Clondalkin

Draft Local Planning Framework

Chief Executive's Report for Proposed
Variation 1 to the County Development
Plan

November 2025

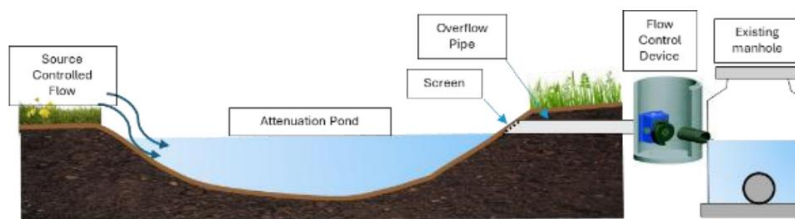
Observation 1, in summary, relates to Flood Risk Management, and in particular, the OPR states that ‘the Planning Authority should consider including the present-day flood risk mapping for Clondalkin to demonstrate the current predicted flood risk’. The full observation is as follows:

- Review opportunity sites with the Local Planning Framework area in the context of SuDS, where integrated and area-based provision of SuDS and green infrastructure can be incorporated in order to avoid reliance on individual site by site solutions; and
- Include the present-day flood risk mapping for Clondalkin as a distinct layer within the Strategic Flood Risk Assessment to demonstrate the current predicted flood risk.

Add 'Stormwater Management' section in A1.1:

'The site is predominantly greenfield and relatively large, providing excellent scope to implement an integrated and sustainable stormwater management strategy. Given its size, the area lends itself well to a masterplan-based SuDS design, where runoff from different development parcels can be managed collectively rather than through separate, site-by-site systems. A stormwater attenuation basin could be strategically located along the southern boundary near River Camac if the topography allows. This basin would serve as the main control feature, temporarily storing surface water before releasing it at a restricted rate—kept to the greenfield runoff equivalent or a practical minimum of 2 L/s in accordance with CIRIA guidance. A typical schematic for such site is illustrated below: Additionally, source control SuDS measures such as swales, rain gardens, and permeable paving should be incorporated within individual plots to slow, treat, and retain runoff close to where it falls. These measures will contribute to the overall network, reducing reliance on hard-engineered solutions and enhancing biodiversity and amenity. Exact location of attenuation site will depend on topographical and hydraulic assessment during later design stages.'

And add the following image in the 'Stormwater Management' section in A1.1:

Extract from Figure 5.9 of the LPF outlining the proposed permeability link from the Ninth Lock Road as far as Woodford Road.

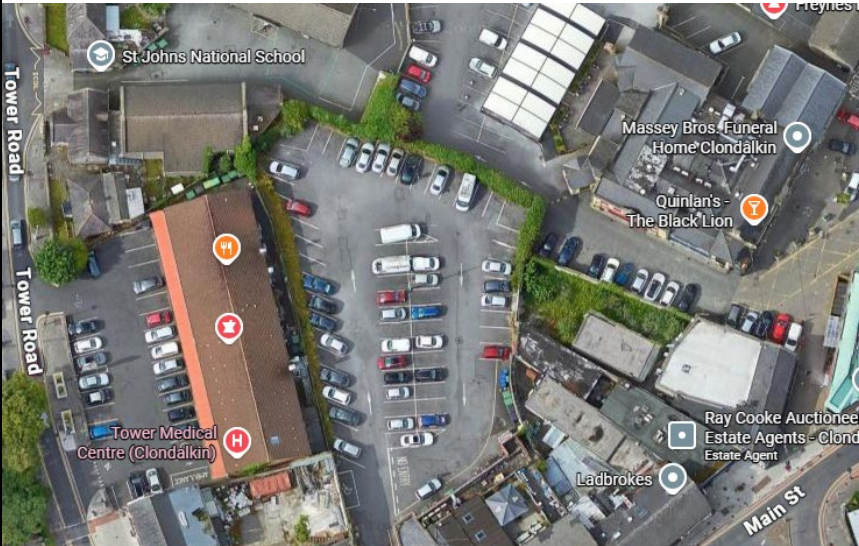
SD-C367-21 Janis Quane	Though submissions recognised that permeability does provide many benefits, it is not something which should be forced on long-established communities, particularly those with ongoing anti-social behaviour. A number of submissions stated there is an IPAS accommodation unit located along Monastery Road, and have raised concerns with those using this accommodation transitioning through the estate to get elsewhere.	 Image extracted from Figure 5.9 of the LPF, highlighting the potential connection between Monastery Heath and Woodford Estate, which would create shorter routes to schools, with the barrier to this connection shown as a circle. The ‘<i>Permeability Best Practice Guide</i>’ (NTA, 2012) is included as an objective in the LPF, and is therefore aligning with H7 Objective 3 in the County Development Plan which states: H7 Objective 3: <i>To support the principle of permeability schemes that provide improved connections between housing estates and their surrounds for walking and cycling, having regard to the National Transport Authority’s Permeability Best Practice Guide (2015) or any subsequent guidelines, including the provisions relating to permeability schemes and anti-social behaviour.</i>

The potential for this route is recognised as a long-term aspiration. It would provide for improved east-west connections within the LPF. Should mixed use or residential development come forward within the current industrial estate, which is provided for within the current town centre zoning, the identification of this route will ensure that opportunities to incorporate it into proposed development are not

lost. The link would also facilitate greater integration with development on the Ninth Lock Framework site, noting that it is an objective to have community facilities within the site along the Ninth Lock Road. The route would also facilitate access to the new BusConnects upgrades along New Nangor Road for those within Riversdale and Mayfield. The '<i>Permeability Best Practice Guide</i>' (NTA, 2012) is included as an objective in the LPF, and is therefore aligning with H7 Objective 3 in the County Development Plan which states: <i>H7 Objective 3: To support the principle of permeability schemes that provide improved connections between housing estates and their surrounds for walking and cycling, having regard to the National Transport Authority's Permeability Best Practice Guide (2015) or any subsequent guidelines, including the provisions relating to permeability schemes and anti-social behaviour.</i> It is recognised that the potential for anti-social behaviour, including safety and security, is a significant concern to the community. The NTA Guide provides examples and detail around best practice in the implementation of opening barriers to movement, the need for universal access and reducing the potential for anti-social behaviour would be included in design considerations. It is an objective within the LPF to:

SM4 Objective 2: <i>To ensure that proposed permeability links are designed in line with the NTA's best practice guidance and in such a way as to reduce the potential for anti-social behaviour, providing wide and inviting openings which are well lit.</i> In addition, a number of objectives in the LTP also make clear that local consultation with communities within which the permeability measures are proposed will be undertaken <u>before</u> implementing any proposed measures. <u>SM4 Objective 1</u> looks to '<i>support the permeability routes and links identified in Figure 5.9 and Table 5.4, <u>subject to further consultation</u>, which will enable quicker and safer access to schools, shops, places of work and social interaction in a pedestrian and cycle friendly environment</i>' There are also multiple objectives relating to the different categories of permeability routes in the LPF to ensure consultation prior to delivery: <i>SM5 Objective 1: To deliver the identified priority permeability routes, subject to local consultation, to facilitate improved connections to schools, increasing the safety of children currently using active travel and providing improved options for</i>

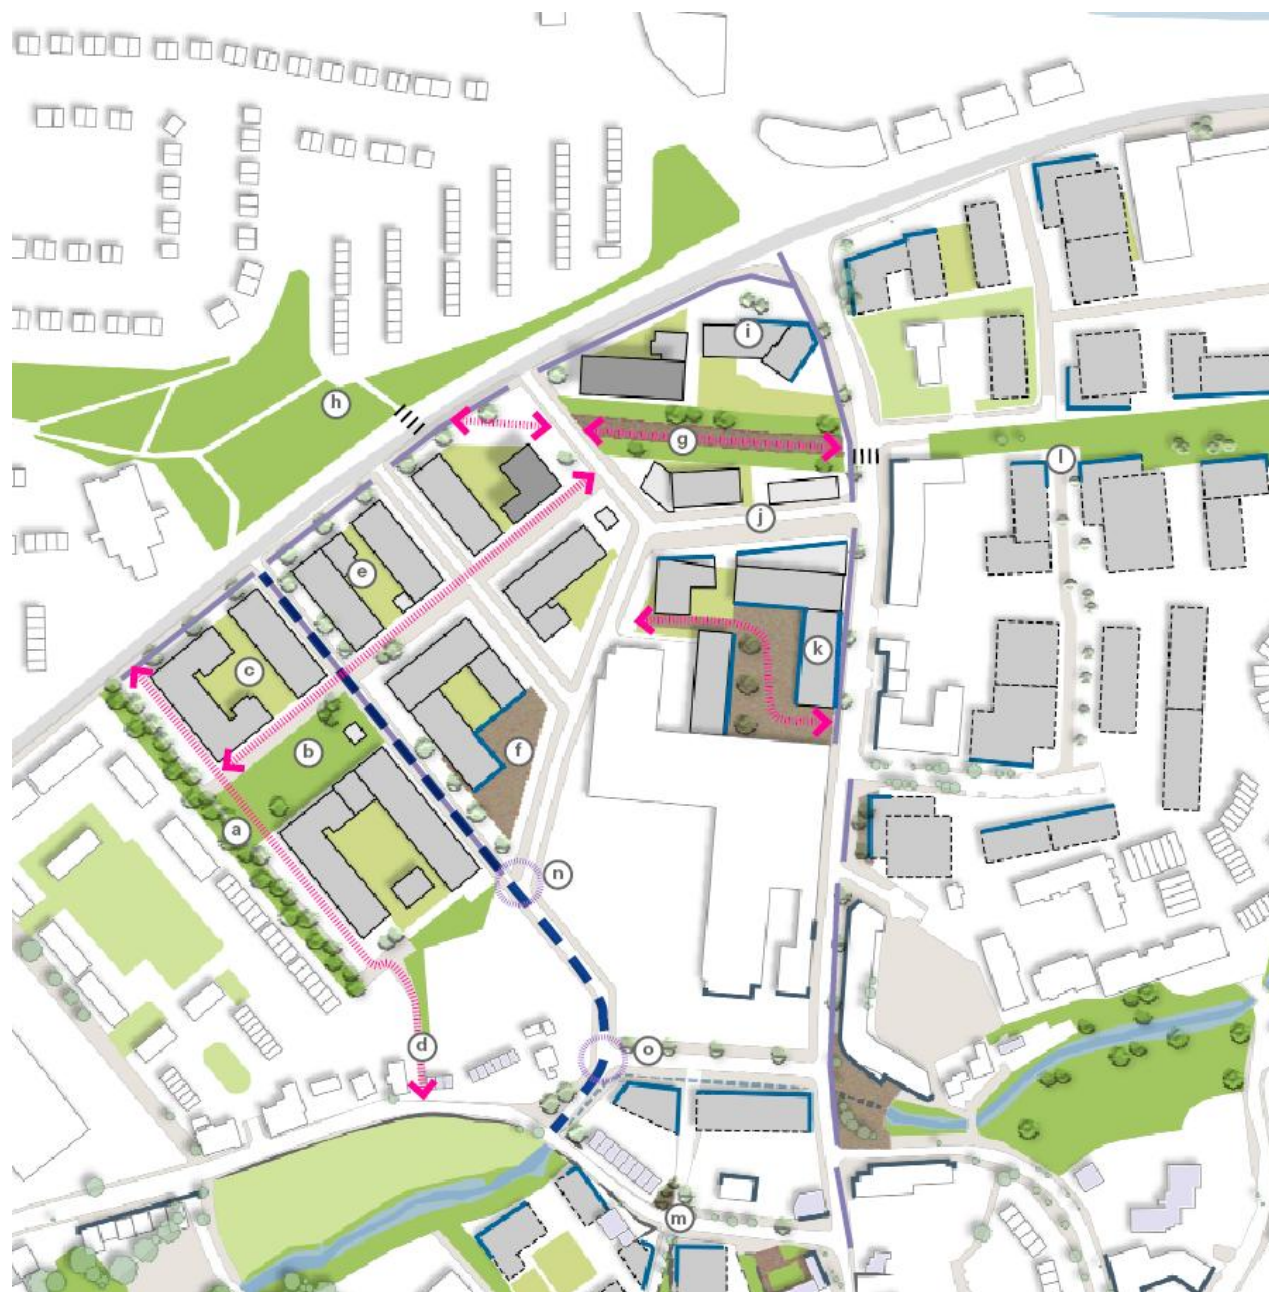
Village Centre Framework Site		
Submission No.	Submission Summary	CE response and recommendation
SD-C367-159 Monica McGill	Village Centre Framework Site The submission queries whether the council will correct Figure 8.10 on Page 91 and the fosse line as it is not limited to the concrete buttress. The submission notes that on Page 75 it states, "The distinctive curve of Orchard Road follows the boundary of the former monastic enclosure (fosse)."	CE Response: The fosse where it is wholly legible either on site or on review of maps is outlined on Figure 8.10 in a yellow colour.

Plinth on Orchard Rd. indicative of line of fosse. The fosse has been identified to the extent possible without detailed archaeological examination. This type of archaeological work is not possible at this time. Having regard to this, the map shown in Figure 8.10 and the description of the fosse, alongside this area being within an archaeological zone of notification is considered sufficient to support the assessment of any planning applications. CE Recommendation: No change to Draft LPF.
--	--	--

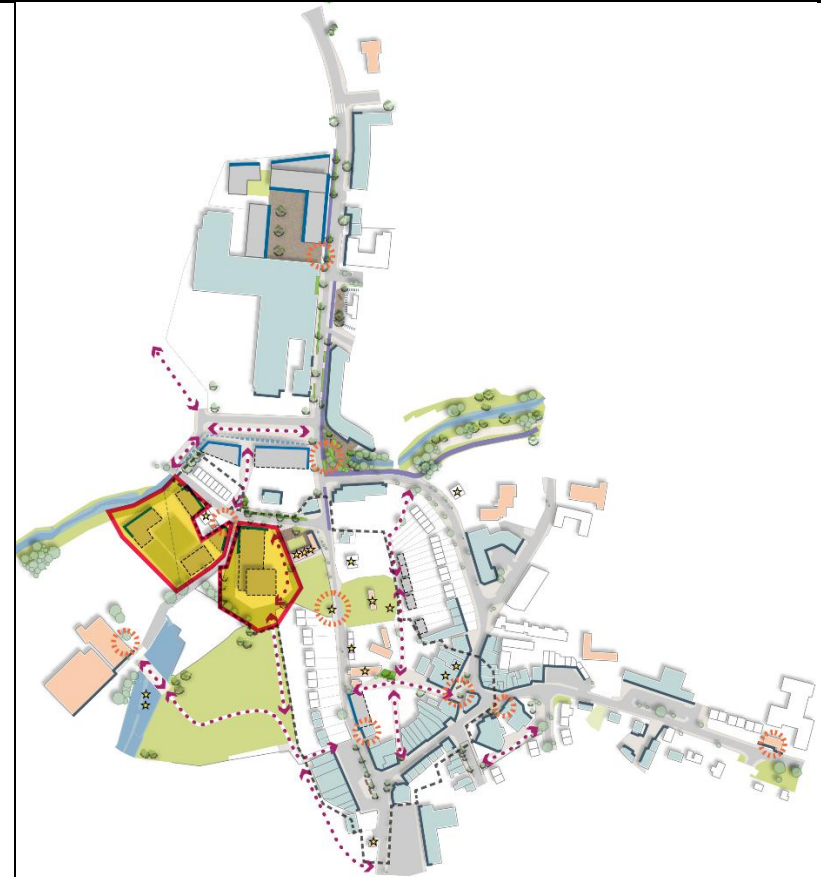
Mini Frameworks		
Submission No.	Submission Summary	CE response and recommendation
SD-C367-170 Clonmill Limited	Mill Centre Car Park BDP, acting on behalf of the Mill Shopping Centre Clondalkin, have made a submission on the mini framework relating to the Mill Centre car park. They acknowledge that the LPF will play a significant role in shaping the character and functionality of Clondalkin, welcoming some of the proposals described but highlighting issues with certain proposals outlined on the shopping centres lands. The submission focuses on the Mini Framework Site's proposal which interact with the Mill Centre lands and its impact on parking, access, servicing and maintenance for the centre. The submission states that a significant amount of development is proposed in the Mill Shopping Centres car park which is in private ownership. This includes the creation of new roads and pathways to connect to the Ninth Lock Framework, with the proposed new access route towards the Ninth Lock Framework (Section 8.5.2) impacting on key operations of the centre. The main issues are provided below: □ Proposed de-culverting and movement opportunities outlined will impact the operation and service of the centre.	CE Response: The LPF provides a planning framework for development within Clondalkin. As part of this, the Urban Design Strategy has identified lands, whether they are public or private, which may come forward for development in the future. These are identified as larger framework sites, mini-frameworks or opportunity sites. For each, key design parameters are identified to guide development should it come forward. The decision whether or not it comes forward is one for the relevant owner/s. The car park area within the Mill Shopping Centre is identified as a mini-framework site, recognising that there is potential for some development and the owner at any time could make a decision to bring this forward. Given its location, adjacent to the large framework site behind the shopping centre, there are clear opportunities to ensure that potential linkages between the sites are not lost. Such linkages would be primarily for walking and cycling – to provide easy access to new populations to the village and to the shopping centre itself and to make journeys shorter and more direct for those coming from the village side to the train station and to the new community. As such, it is considered very important to retain these potential linkages in the LPF.

redesign and creating short and long term disruption to the busy retail centre. Though the Mini framework plan proposes development opportunities with proposed units aligning to the path of the Camac, the location of them overshadows the proposed active route outlined in the LPF, the existing car park and the Mill Shopping Centre. This is turn will reduce the Mill's visibility and street presence on Tower Road and Old Nangor Road.	to placemaking within Clondalkin and to the environment around the shopping centre, it is recognised that there may be feasibility and other issues which make it difficult to achieve. The Council would be willing to work with the landowner to investigate whether there are any funding mechanisms which could help bring this forward. The submission is concerned at the estimated loss of car parking spaces that development may necessitate. Should development come forward, consideration would have to be given to the rationalisation of car parking, ensuring that it continues to meet the needs of those using the shopping centre. The mini-framework is not requiring development on the site but it is recognising that there may be potential on the site for development and in that regard, it is setting out design parameters to guide development in the event that a planning application comes forward. It is also noted that SM5 Objective 3 needs to be changed for clarity purposes: <i>To ensure that new development and key lands maximise the potential for active travel connectivity between the site to the village centre, local services and schools and to public transport'</i> CE Recommendation: Amend SM5 Objective 3:

From <i>‘To ensure that new development and key lands maximise the potential for active travel connectivity between the site to the village centre, local services and schools and to public transport’</i> To <i>‘To ensure that new development and key lands maximise the potential for active travel connectivity between areas outside the village centre, including the Ninth Lock Framework site, to the village centre, local services and schools and to public transport.’</i> And Amend Figure 8.32 on page 104 to remove reference to ‘vehicle movement’ and to illustrate more clearly the long term high capacity public transport route, as identified in the adopted County Development Plan. And Include the identification of the permeability links in the Figure 8.32 Key, identified as ‘n’ and ‘o’ between the Ninth Lock Framework site and the Mill Centre site, as shown on the revised map below.
--	--	--

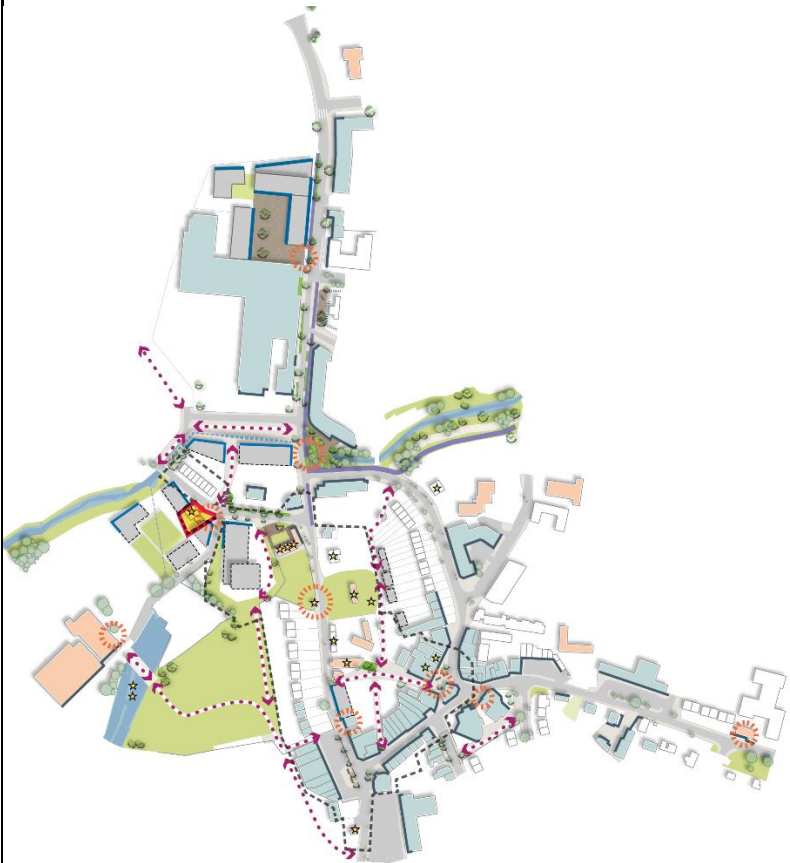
SD-C367-55 Cllr Francis Timmons	Old Nangor Road Infill Site The submission refers to Figure 8.15 on page 83 of the Local Planning Framework and requests that the image makes clear whether the Old Nangor Road is one or two way.	CE Response: The submission is noted. For clarity, it is noted that Figure 8.15 is on page 93. The image on Old Nangor Road is intended to convey that it remains two way. However, it is acknowledged that the graphics could be improved to make this more clear. It is also noted that the site location of the Old Nangor Road Mini Framework in Figure 8.13 is incorrect and needs to be corrected. CE Recommendation: Amend Figure 8.13 on page 93 to illustrate the correct location of the Old Nangor Road Mini Framework location.
--	---	---

And amend Figure 8.15 on page 93 to illustrate more clearly that Old Nangor Road is two way.
